RE: Revised CMS

Thank you for revising the Corrective Measures Study (CMS) to incorporate some of the agency review comments. As agreed, I plan on taking this version to public hearing during early 2004. As such we do not expect you to revise the document in response to any remaining issues, nor has the State of Maine Department of Environmental Protection provided a detailed comment letter on the revised CMS. This letter does contain our initial thoughts on the document and attached to it are the U.S. Environmental Protection Agency's comments (Attachment 2).

## Attachment 2

## Landfills 3 and 4

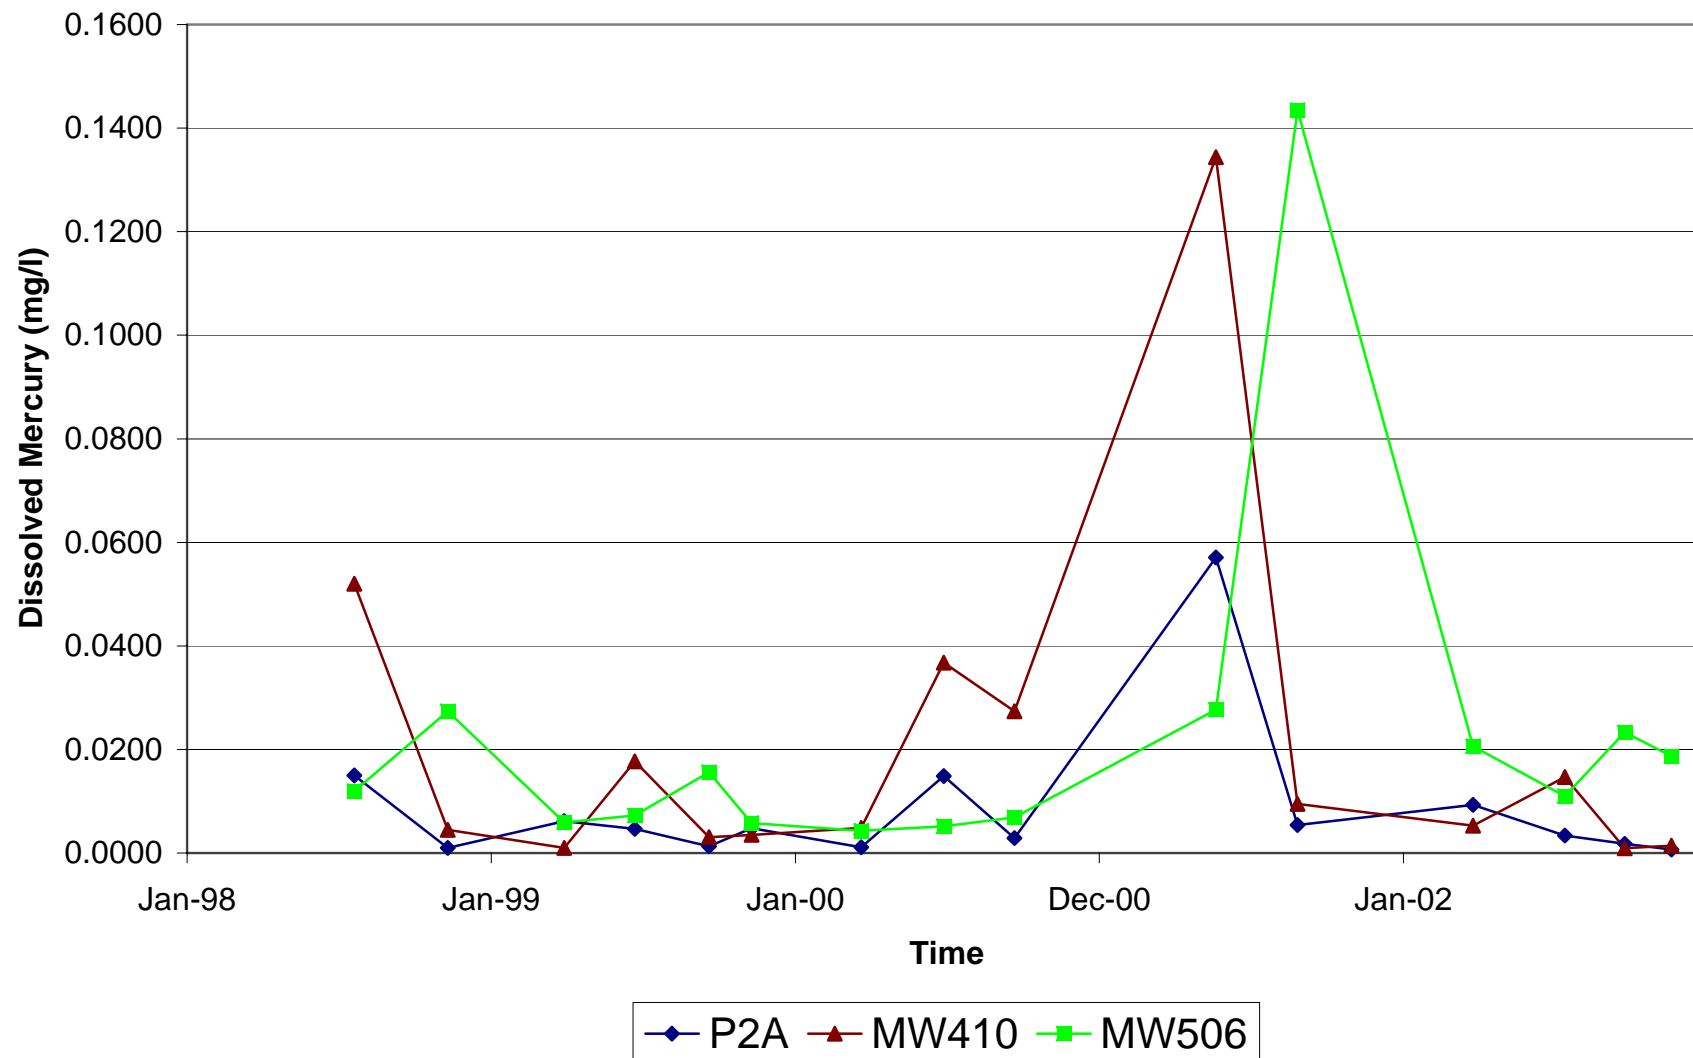
There is some new material in section 3.6 regarding the Landfill Ridge landfills that appears to be inaccurate. The report states that “Groundwater sampling immediately downgradient of these areas shows that groundwater PMPS are not being exceeded.” Attached is a graph (Attachment 1) that plots trends in dissolved mercury concentrations in monitoring wells that are down-gradient from Landfill 3 and Landfill 4. The data is from the Comprehensive Monitoring Program for 1998 through 2002. Wells MW-410-B1, MW506-B1 and P-2A have mercury concentrations that are usually above the groundwater protection standard concentration of 0.002 mg/l, even as much as seventy times the standard. Clearly the PMPS down-gradient of the wastes on the landfill ridge is frequently exceeded, in contradiction of the report. While most of the ground water monitored by those wells travels through the plant area and will be collected by the extraction wells below the Landfill 1 Area, the persistent leaching of hazardous contaminants from these landfills may prolong the time that ground water collection will be required. CDM and Malinckrodt have never acknowledged that these landfills are leaking, but they have never offered a plausible alternative explanation of the persistence of mercury, chloroform, carbon tetrachloride and salts in these wells.

The monitoring data from Landfill 2 and Landfill 5 seems to demonstrate that over some reasonable time the leachable mercury in the soils and wastes at the site will be exhausted. The mercury remaining will be irreversibly adsorbed and the flux to the river will be acceptably small. The monitoring data from around Landfill 4 and Landfill 3 however seems to show ongoing leaching of mercury twenty-plus years after they were capped. Because the data indicates these two areas are different, the Department believes all of the wastes and contaminated soils should be isolated from ground water and infiltration so that mercury flux will be limited over the long term.
